March 19, 2019

Project No. 12091-01

**Subject:** *Preliminary Geotechnical Evaluation and Response to City Review Comments for Proposed San Pedro Distribution Center, 1599 W. John S. Gibson Boulevard, Los Angeles, California*

## **5.0 RESPONSE TO CITY REVIEW COMMENTS**

# **Geotechnical Map**

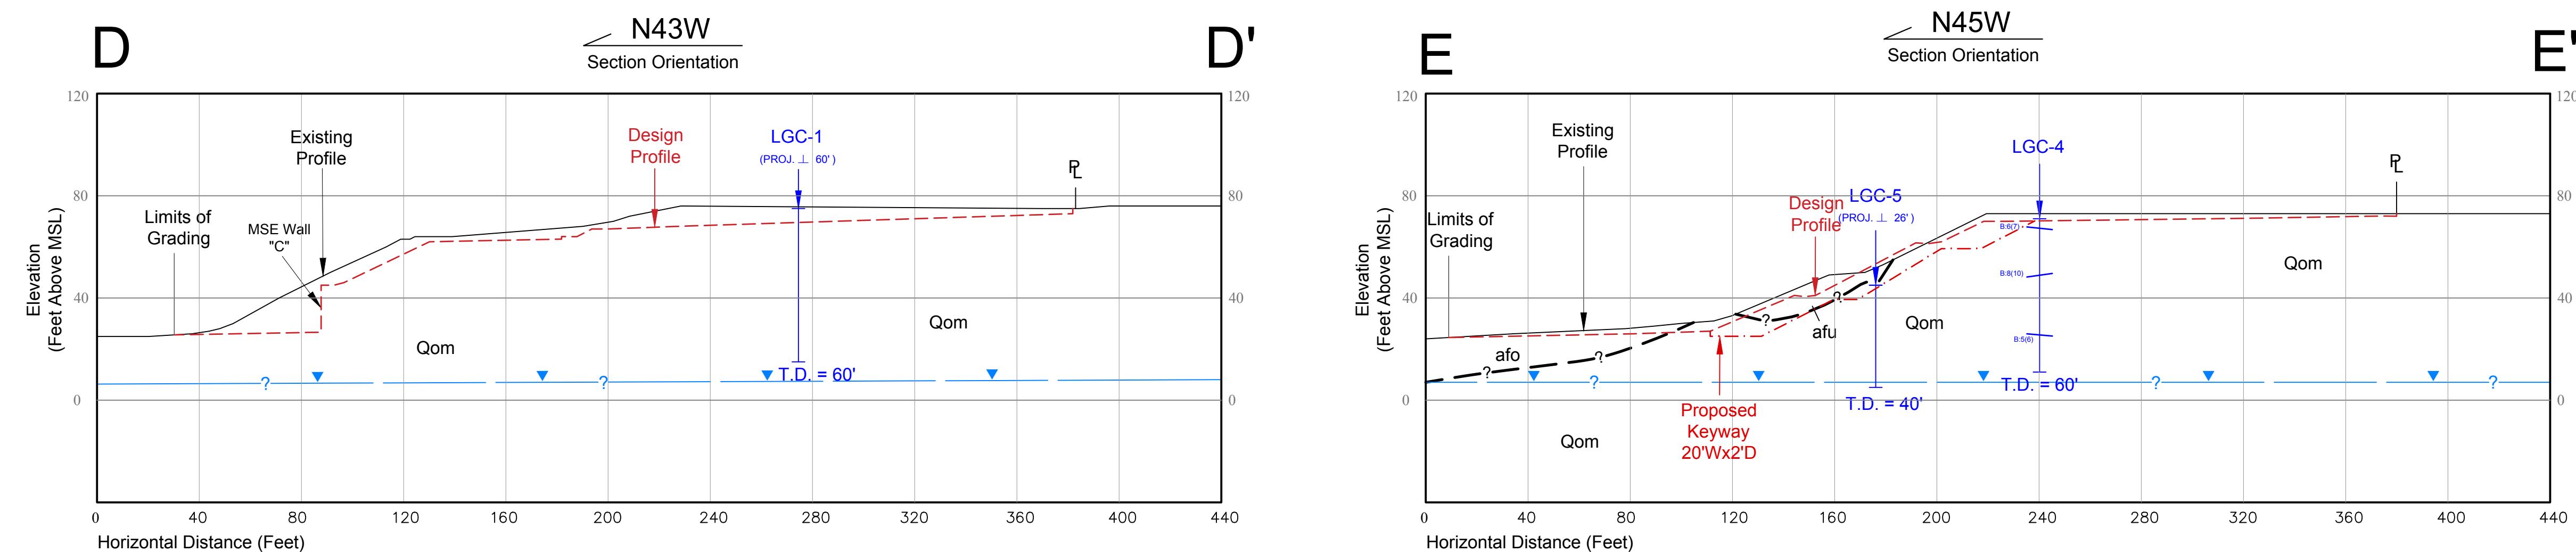
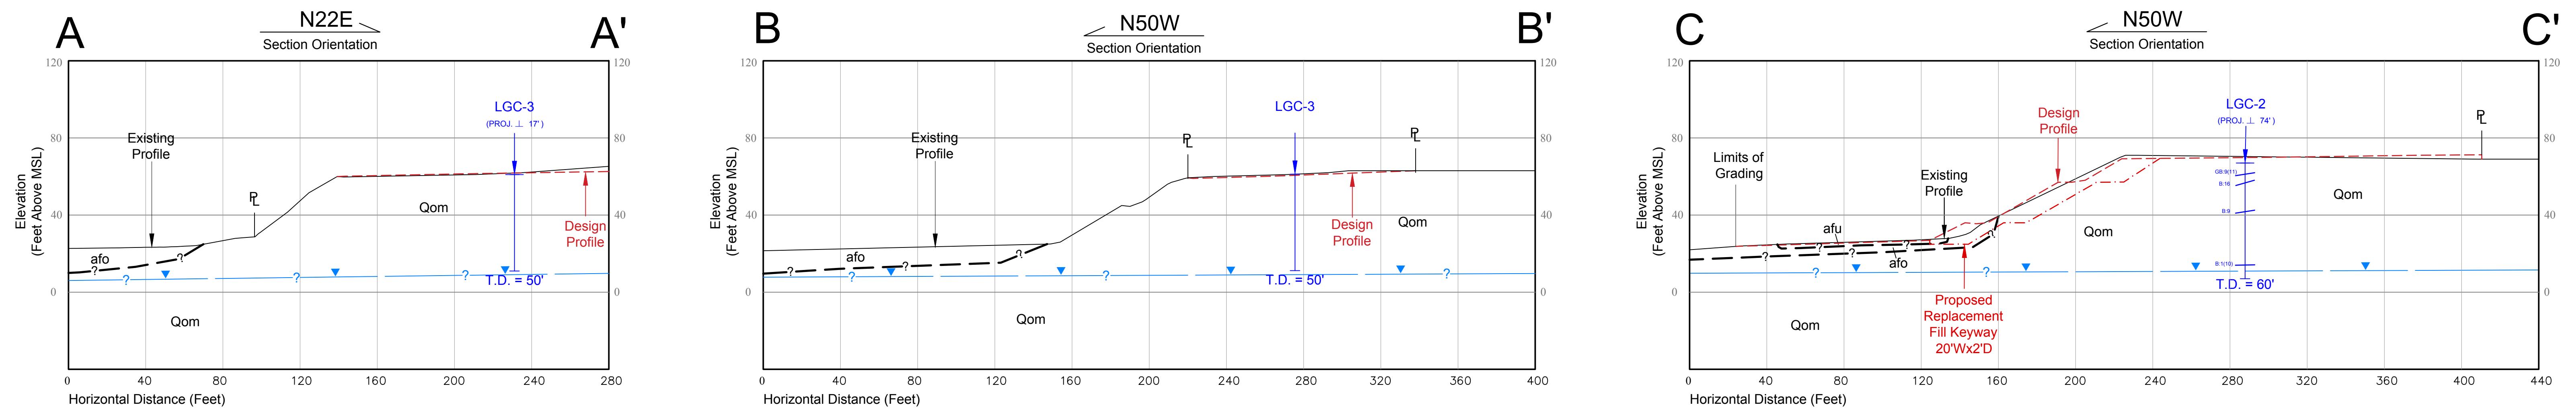
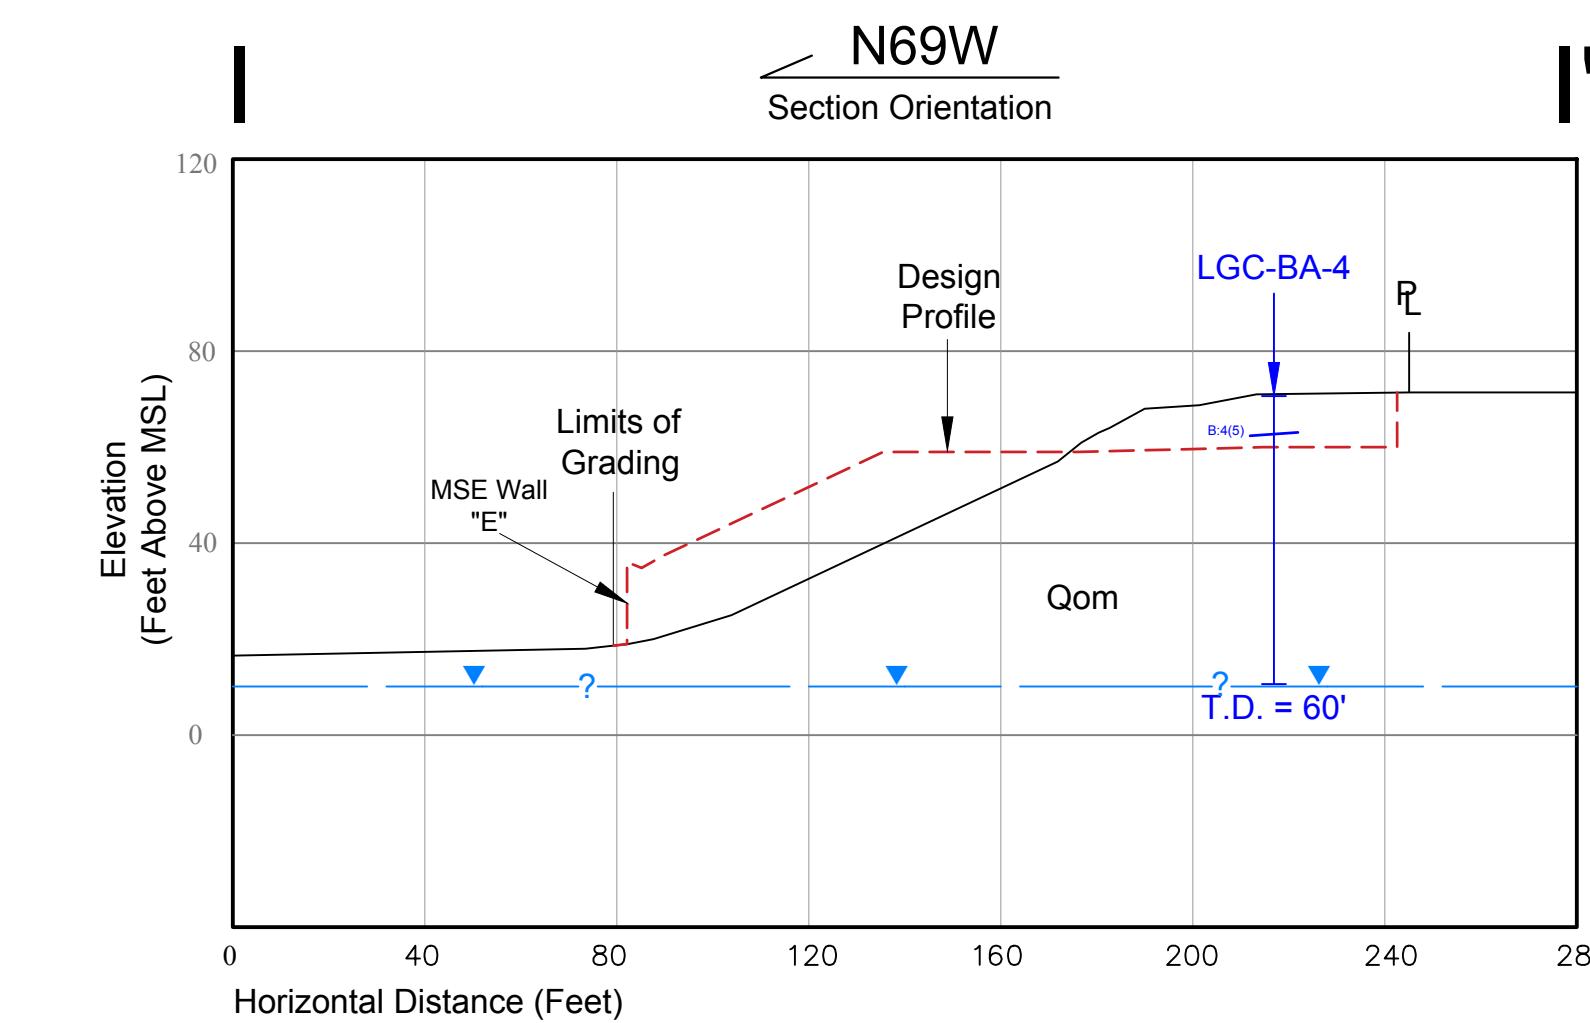
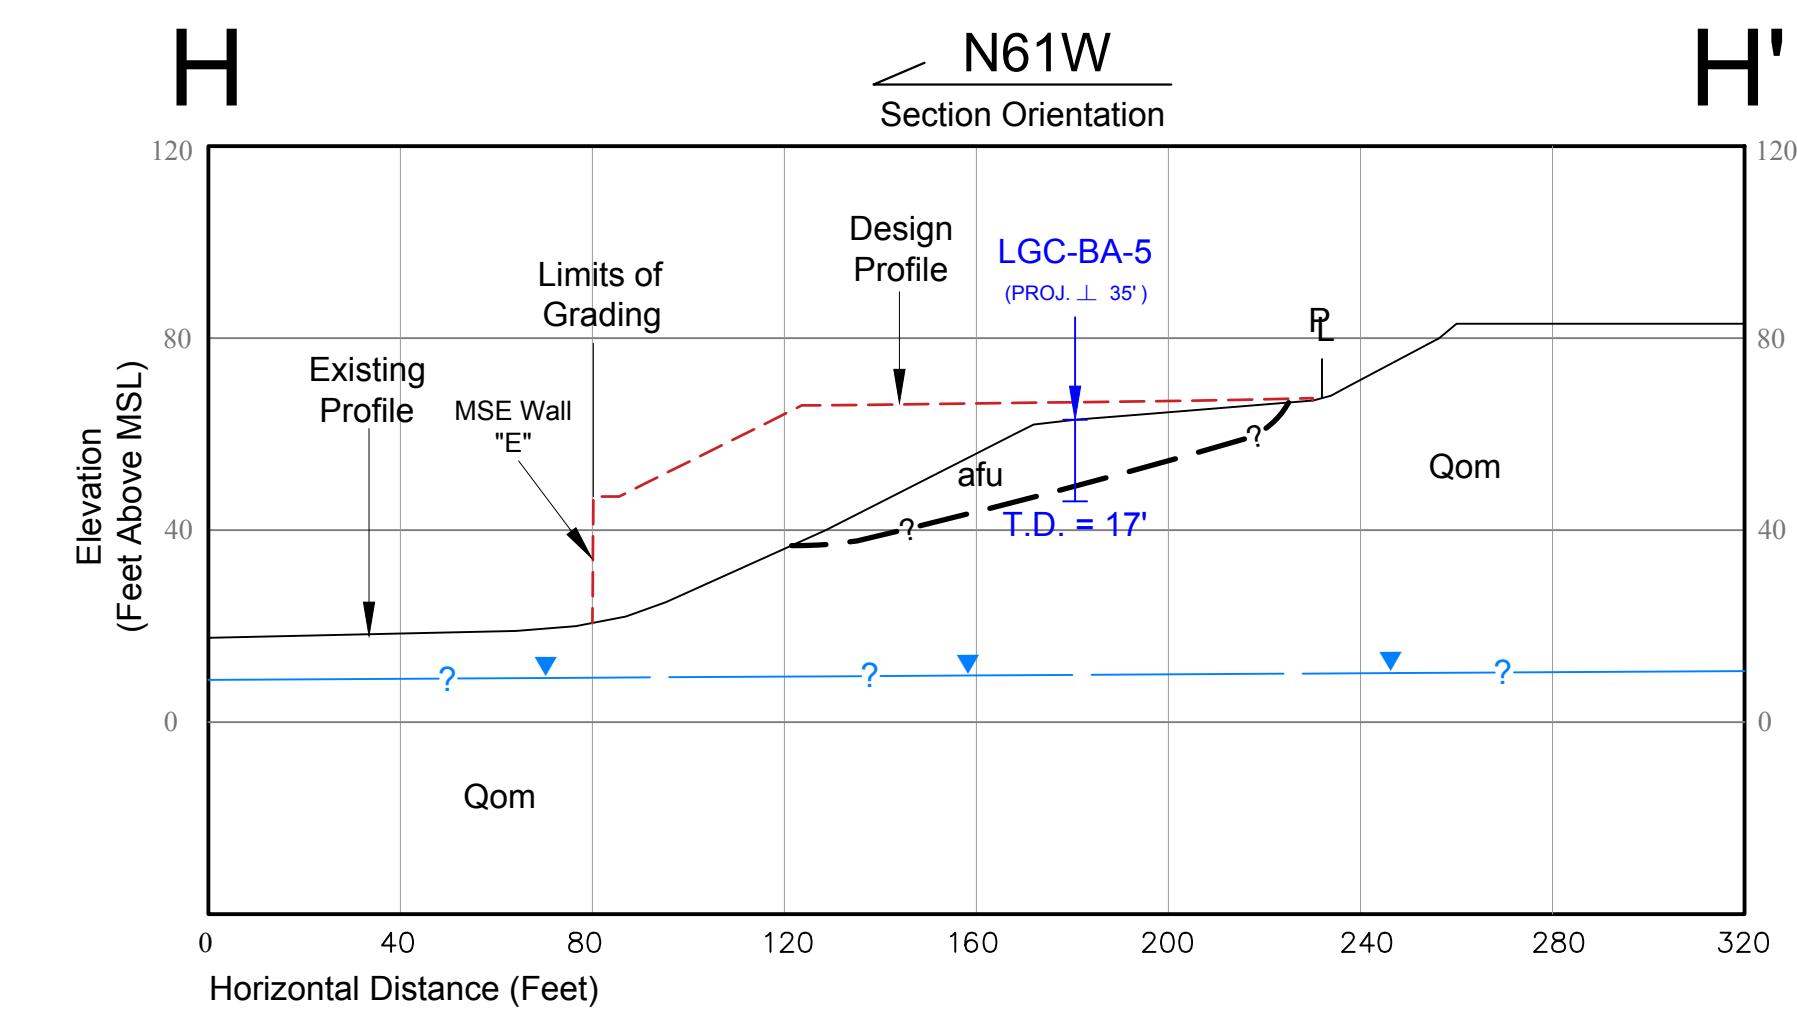
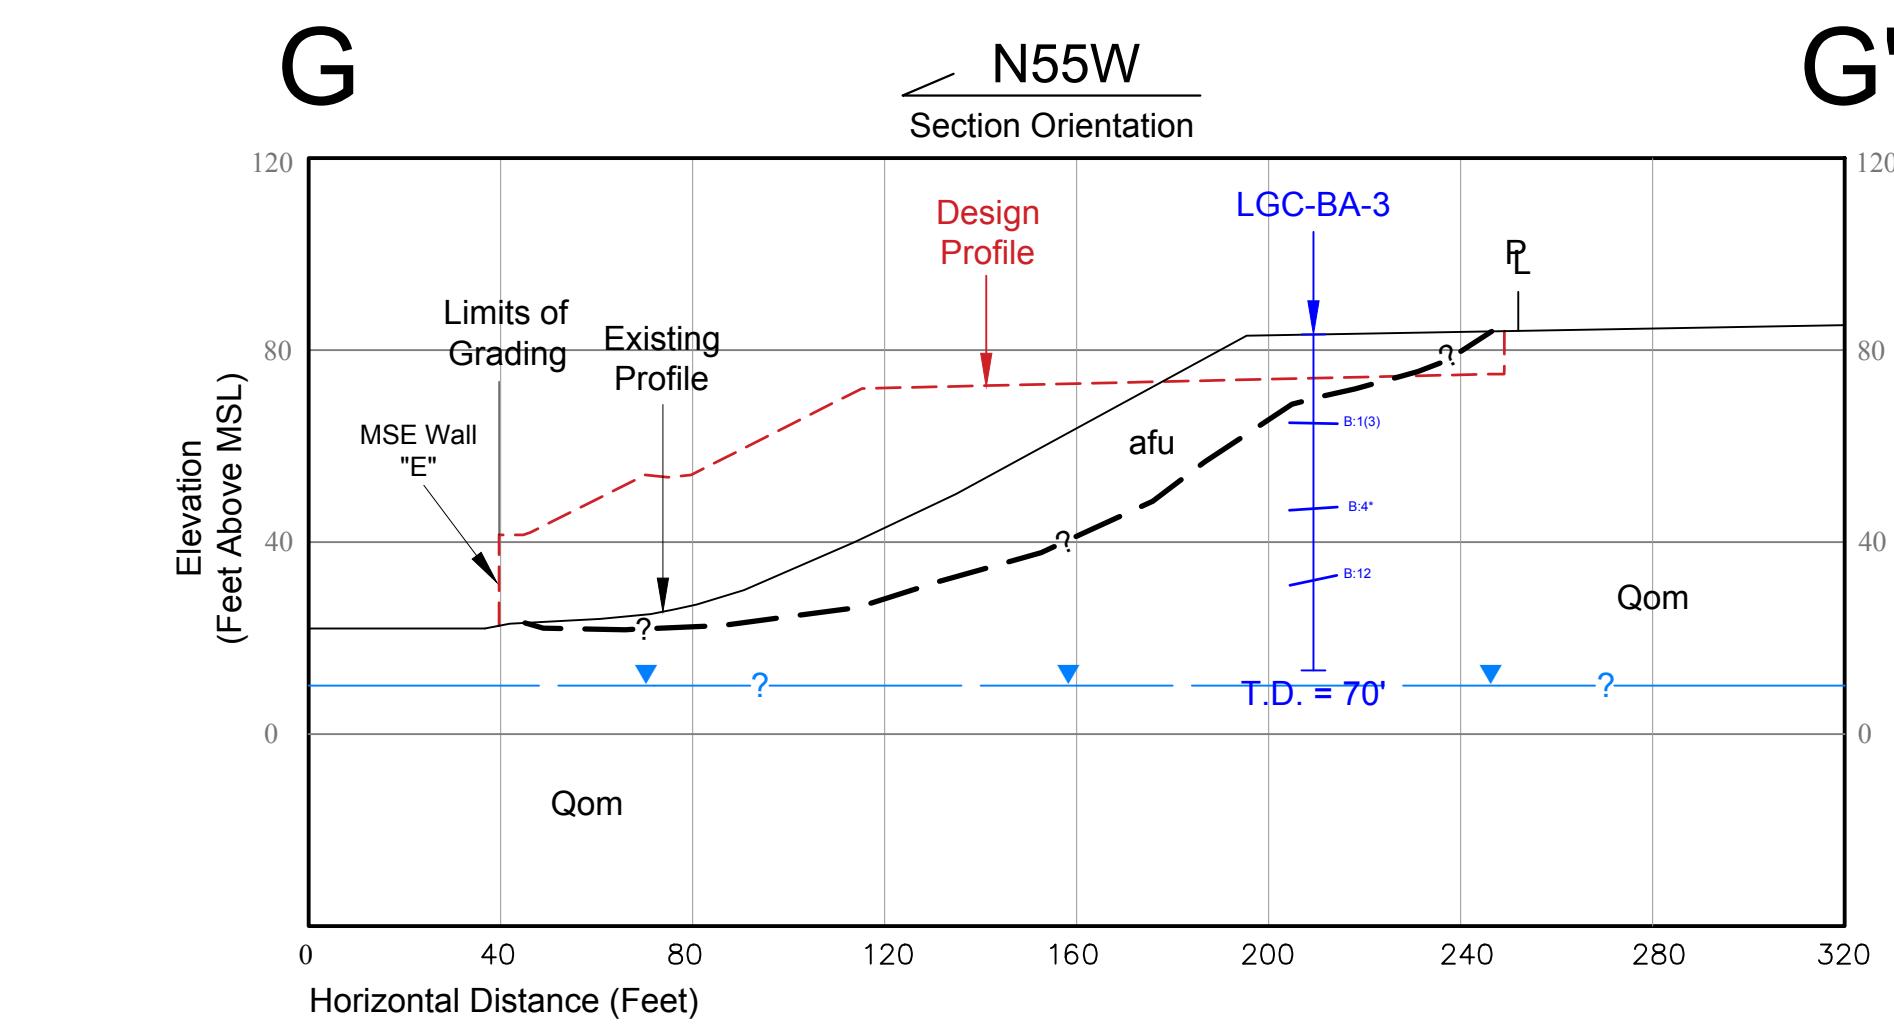
"Provide a geologic map and cross sections that are based upon conceptual grading or site development plans, to illustrate all proposed and existing contours relative to the planned grading and/or construction, along with all off-site slopes and conditions that could adversely affect the stability or safety of the site (7006.3.2). The geologic map and cross sections shall depict the top and bottom of slopes; lithologic contacts; bedding attitudes; locations of slumps, landslides, or faults relative to the subject site; existing and proposed topographic profiles; existing and proposed structures; and, required Code setbacks. (7006.3.2)"

"Provide geological cross sections illustrating existing and proposed grades and structures through the highest, steepest and geologically critical slopes."

Refer to the attached Geotechnical Map and Geotechnical Cross Sections (Sheets 1 through 5). No building structures are planned for the site.
